**RE: Hampton Inn (Holly Ave)
Grading Plan and Drainage Report
Engineer's Stamp Date – 4-22-2016
Hydrology File: C18D073B**

Based upon the information provided in your submittal received 4-22-2016, the above referenced Grading Plan and Drainage Report is approved for Site Plan for Building Permit.

**DEVELOPMENT REVIEW BOARD
HYDROLOGY SECTION**

Project: Hampton Hotel

Channel Capacity

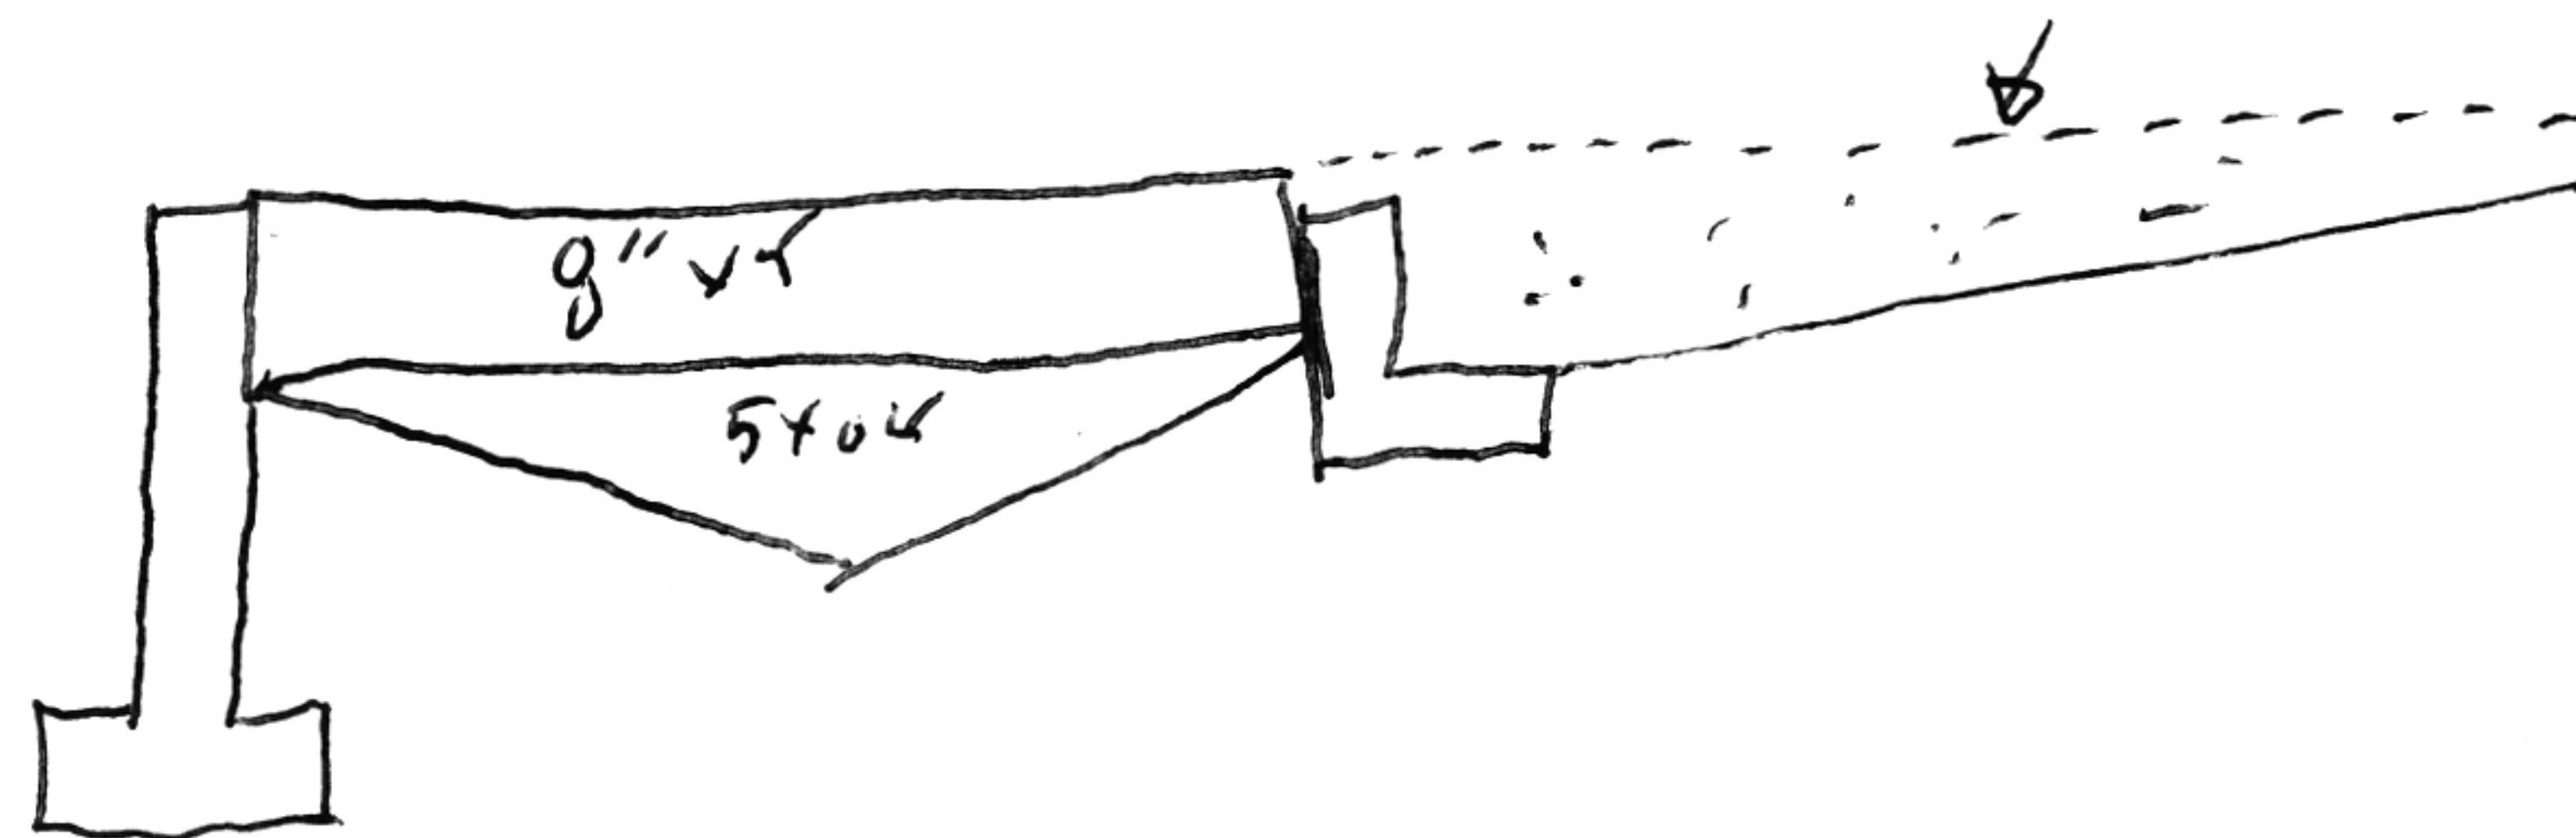
- Hydrology has an approved grading plan, and drainage report (stamp date 11-18-15), for *Site Plan approval*.
- The drainage report states that this site receives inland flows. A private cross lot drainage easement may be needed. We are adding blanket cross lot drainage
- Tract A was to discharge thru a shared access drive along the eastern edge, but it appears from the grading that it now discharges thru this site. Provide supplement to drainage report showing how much flow will be entering from Tract A, and how it will discharge. Flows are accepted, passed thru north drive isle onto holly
- Lots 21 and B1 both discharge thru this site. Was swale was sized to accommodate these flows? Report needs supplement information addressing offsite flows.

The channel is irregular shaped so we calculated capacity in section. The top section does not have roughness on the bottoms so the capacity is greater show here

Additional capacity in parking lot not included but available.

We have added channel section calculations
